ENGINEERING MEETING

Alternate 5 Coil PF Design And Access Considerations

JULY 11, 2001

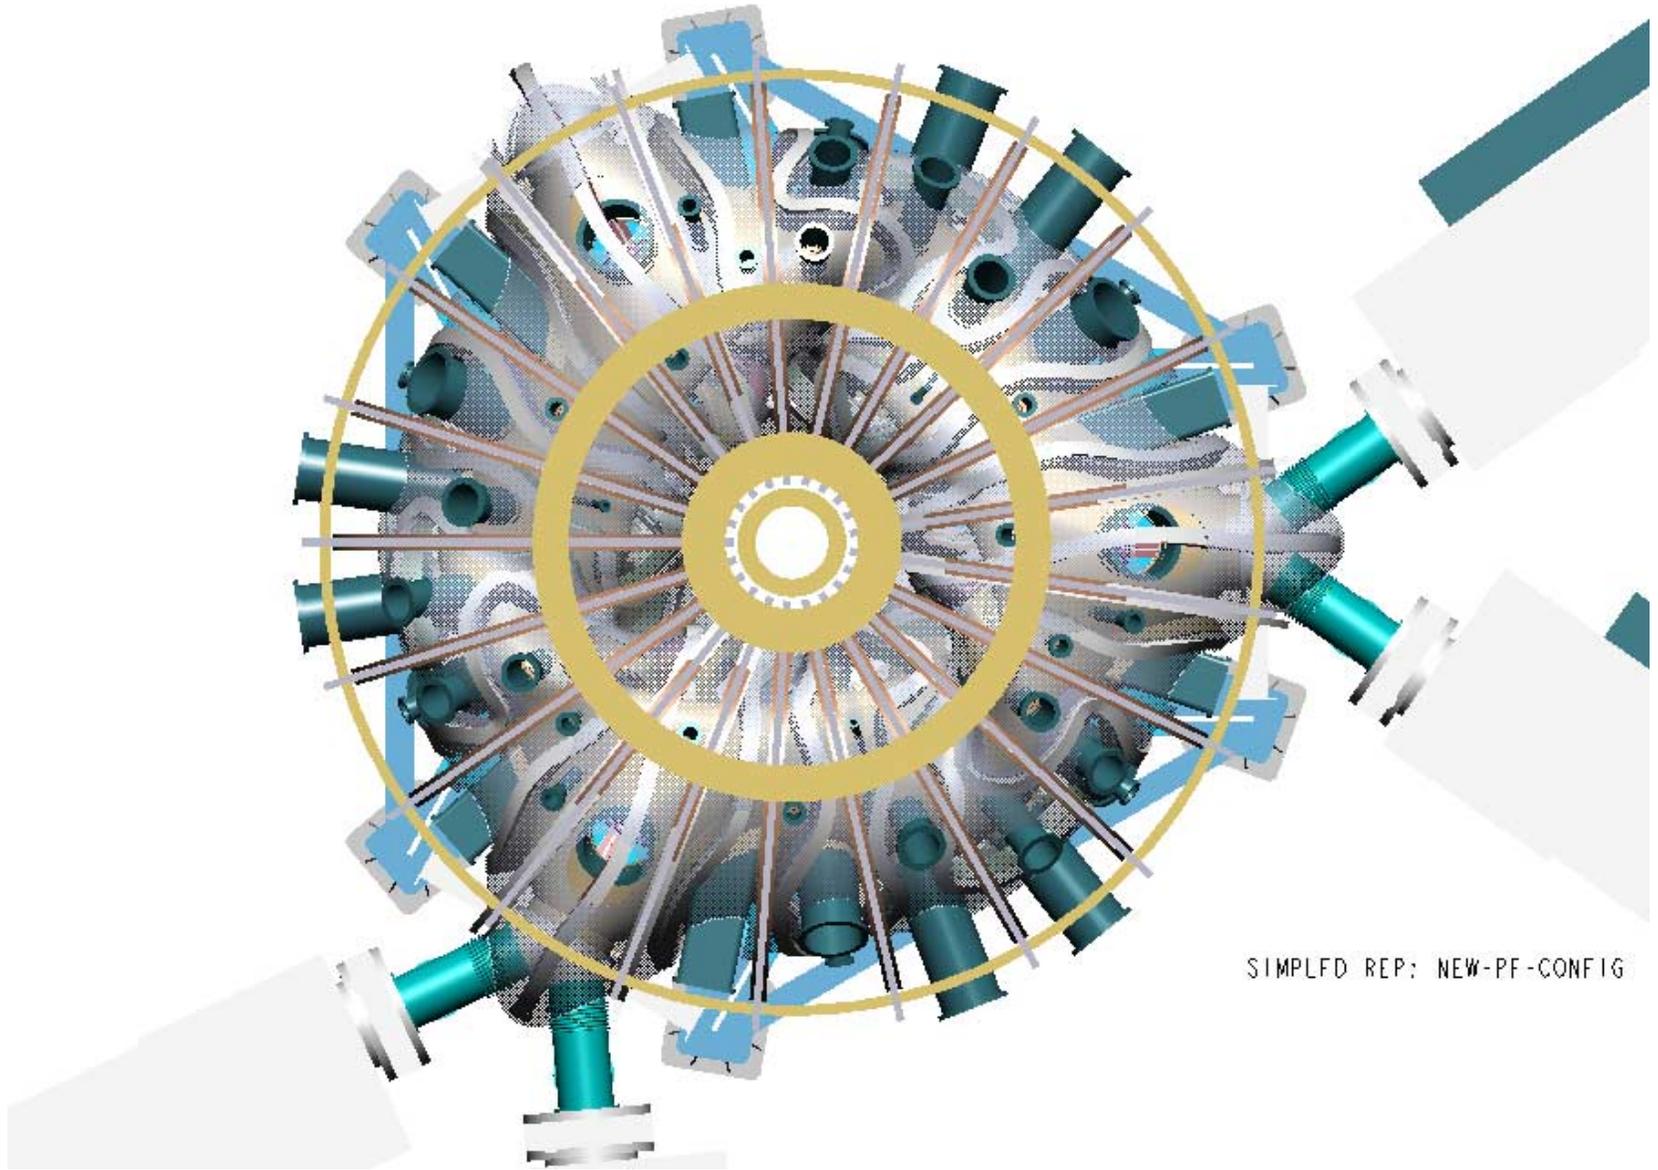
Top view – Access from top appears to be unrestricted by PF

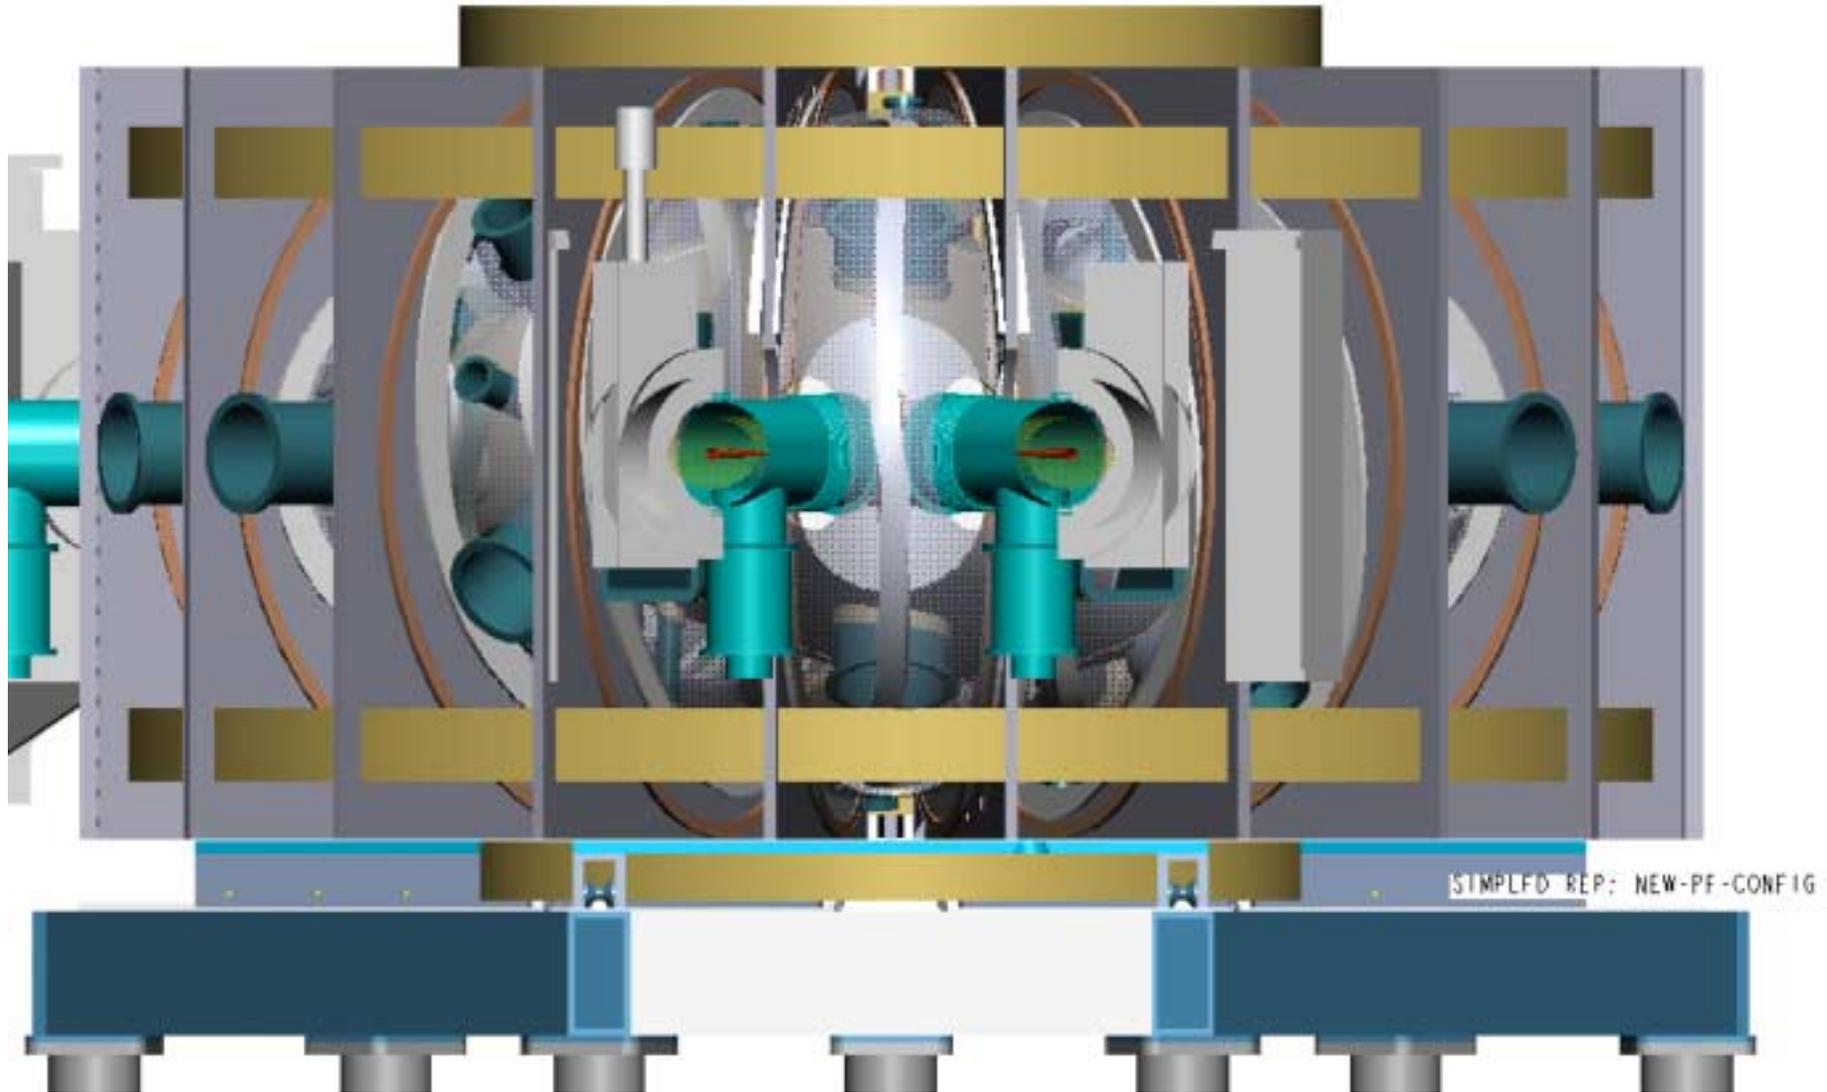
Neutral Beam boxes removed. Access in this area is good.

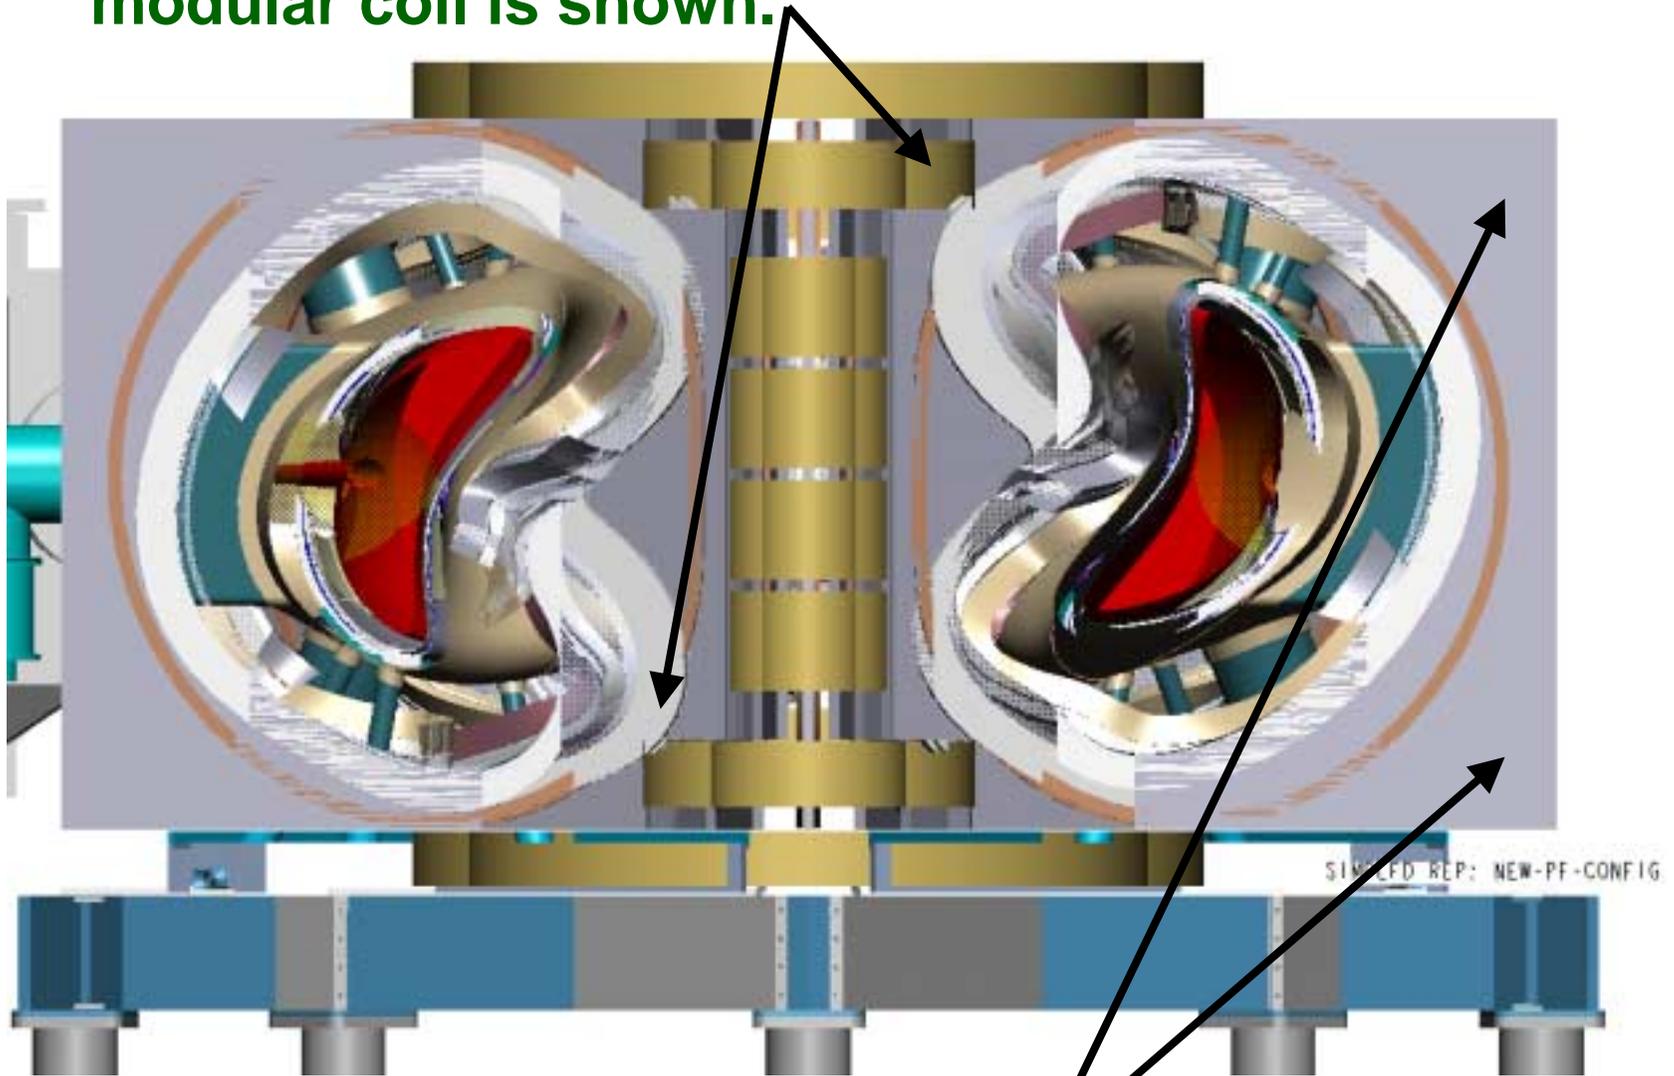
Access is not restricted in this view but an interference with PF3 and the modular coil is shown.

PF5 is not shown in this view.

PF3 should be repositioned to eliminate interference with modular coil.

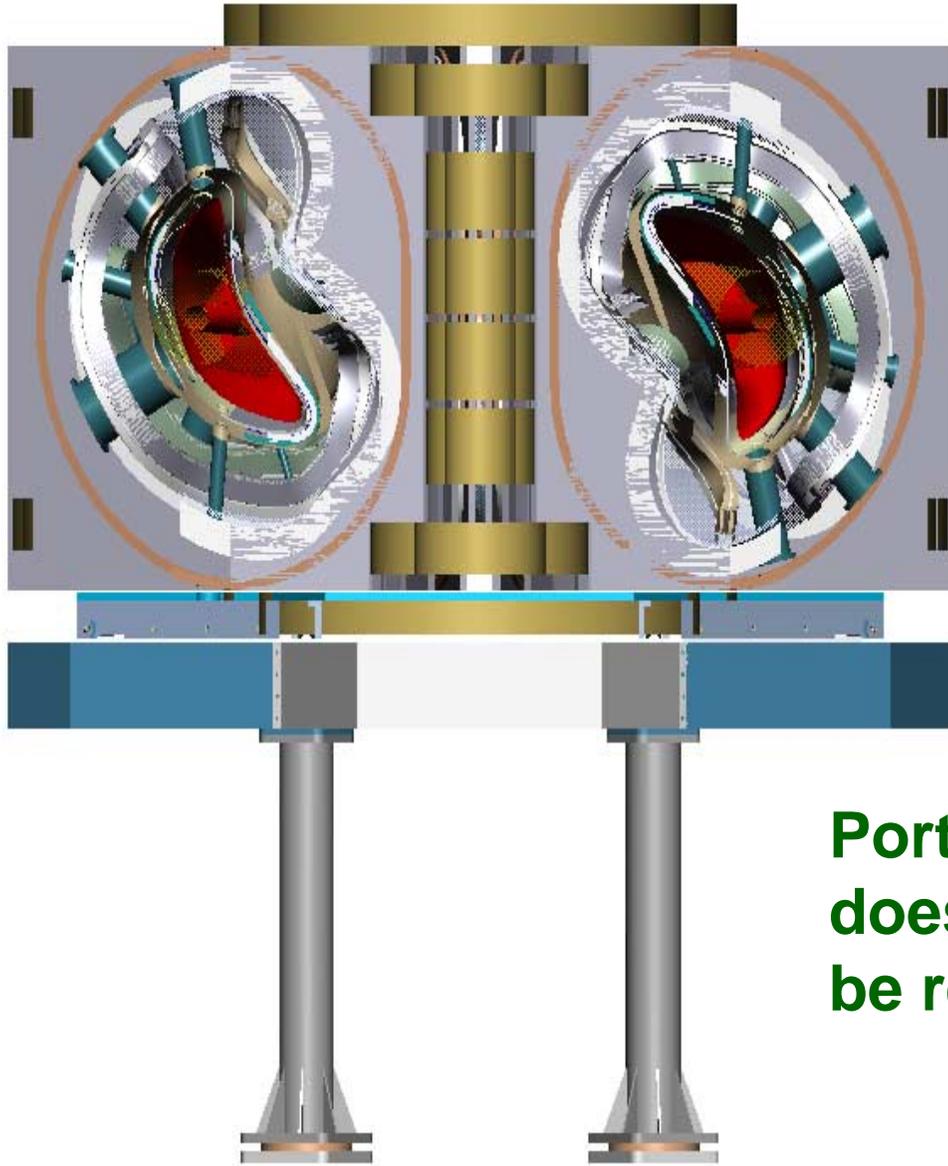
**Port configuration
does not appear to
be restricted by PF.**
